**FEDERAL AVIATION ADMINISTRATION
AIRWORTHINESS DIRECTIVES**

**SMALL AIRCRAFT, ROTORCRAFT, GLIDERS
BALLOONS, AIRSHIPS, AND UAS**

BIWEEKLY 2024-20

09/23/2024 - 10/06/2024

Figure 1 to Paragraph (g)(1)(i)-Flex Plate Inspection

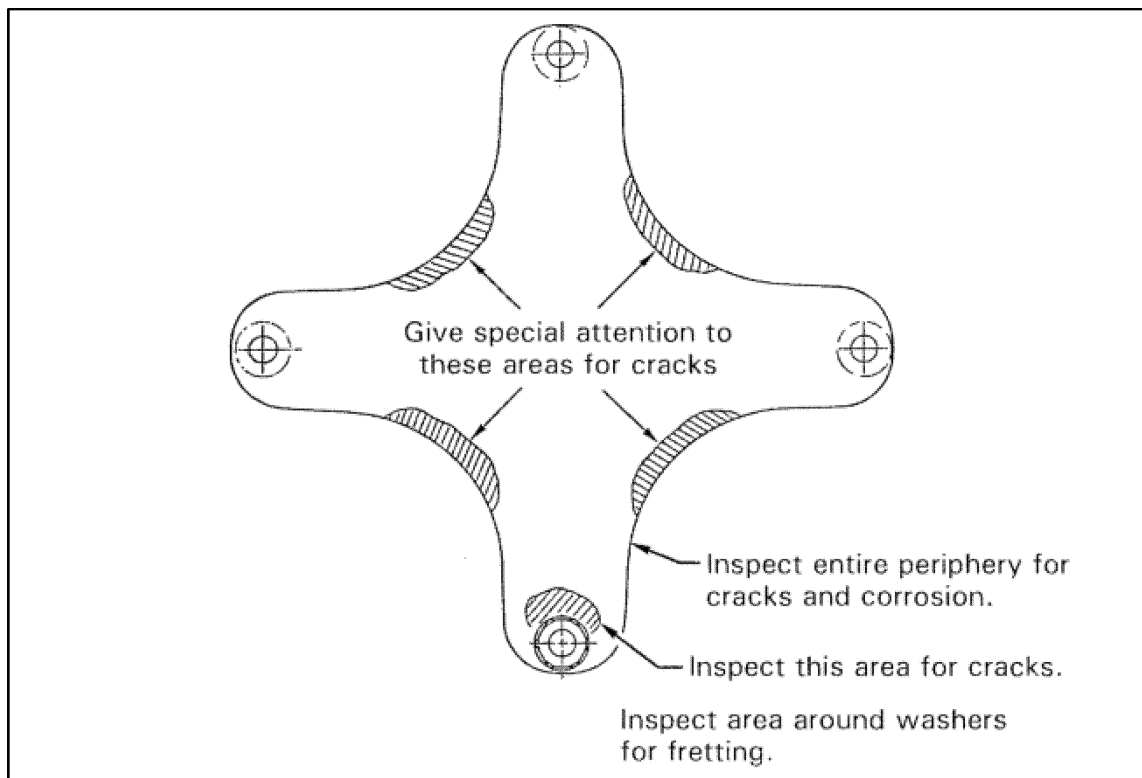
(i) Visually inspect forward flex plate assembly (flex plate) part number (P/N) C947-1 for any loose fasteners, cracks, fretting, corrosion, wear, and to ensure that the washers are bonded to both sides of each flex plate arm, in the areas depicted in Figure 1 to paragraph (g)(1)(i) of this AD. If there is any loose

fastener (can be moved by hand), crack, fretting, corrosion, or wear that consists of the washers not securely bonded to both sides of each flex plate arm, before further flight, remove the flex plate from service and replace with an airworthy flex plate.
